Subject: Docket No. 50-206
Pressurized Thermal Shock to Reactor Pressure Vessels
San Onofre Nuclear Generating Station
Unit 1

Southern California Edison's Response To
NRC Request For Additional Information
Concerning
Pressurized Thermal Shock
And
Regarding the "150" Day Response To NRC Letter Dated August 21, 1981
For
San Onofre Unit 1
Docket No. 50-206

FIGURE 1
COMPARISON OF SAN ONOFRE UNIT 1
AND DESIGN BASIS PERIPHERAL POWER DISTRIBUTIONS

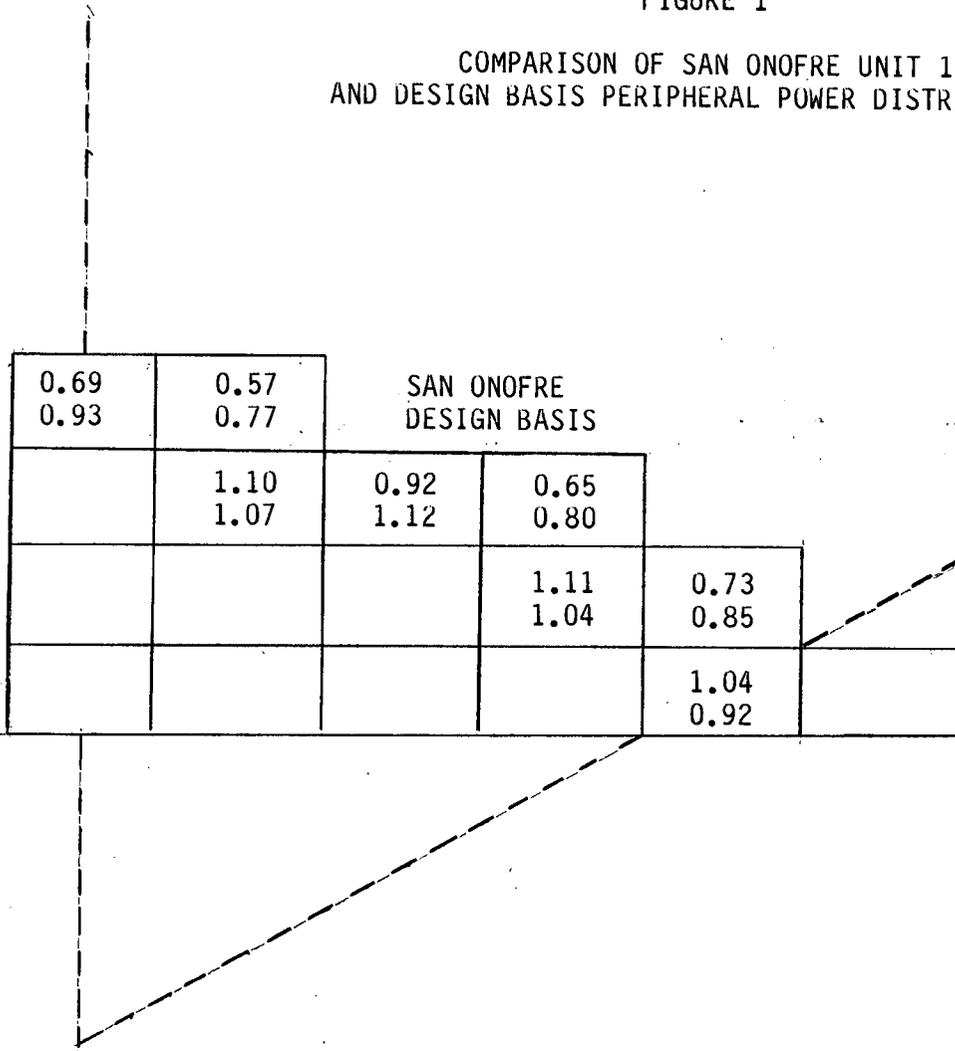
1. Provide the following information related to fluence determination:
 - (A) Plant specific information which would allow determination of the pressure vessel fluence. Such information should contain as built core and pressure vessel dimensions, regional material composition and neutron source for a two-dimensional (R-O) and (R-Z) neutron transport solution, and
 - (B) Plant specific values of the pressure vessel fluence and its estimated uncertainty.

Plant specific peripheral assembly power distributions for cycles 1 through 8 are tabulated in Table 2. These data were extracted from the appropriate core design reports (WCAP's 3269-07, 7490, 7799, 8060, 8490, 8933, 9334, 9633). Bias factors were applied to the design power distributions consistent with the methodology outlined in WCAP 10019. Also presented in Table 2 are the eight cycle time average power distributions for the peripheral assemblies. These average distributions were obtained by burnup weighting of the individual fuel cycle data sets. A comparison of the cycle average data with the design basis peripheral power distribution is depicted in Figure 1. An examination of Figure 1 shows that the plant specific power distribution will result in a somewhat lower fluence projection than that which would be calculated using the design basis distribution. It would appear that a reduction in pressure vessel fluence on the order of 20% might be realized. However, at this time neutron transport calculations using the plant specific power distributions have not been carried out. These computations must be complete before any reduction in the current pressure vessel fluence can be certified. It must also be reemphasized that the plant specific data are applicable only for establishing the present condition of the pressure vessel. They should not be used to project forward in time.

An examination was also made of the variations in the power density gradients for the peripheral fuel assemblies at beginning of life and end of life for both 15 x 15 and 17 x 17 fuel rod arrays. The conclusion of this study was that these spatial gradients, relative to an assembly average power of 1.0, were quite similar in all cases examined.

Therefore, the gradient information previously provided in the 150 day response should also be used to generate plant specific fluence values for San Onofre Unit 1. Likewise, the time averaged axial power distribution supplied in the 150 day response is suitable for the current analysis.
